# Public Works Department - Carby Street Offices

## Town of Westwood ADA Transition Plan

May 2023

Institute for Human Centered Design

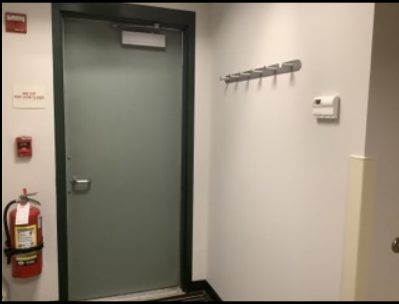
<b>Interior Access Route</b>												
8	Women's Multi-User Toilet Room	1		Interior Access Route	N/A		Obstructed by protruding objects	9.75"	Provide a cane-detectable barrier underneath the automatic external defibrillator (AED) while ensuring the fire extinguisher can still be accessed.	1	398	\$398
9	Women's Multi-User Toilet Room	1		Interior Access Route	N/A		Vertical clearance < 80" above finished floor	76"	Further study will be needed to determine whether it is technically feasible to bring the vertical clearance into full compliance with the ADA Standards. Consider adding signage that says, "Low Headroom" or, "Low Ceiling". Alternatively, provide contrasting painting or padding underneath the obstruction.	1	302	\$302
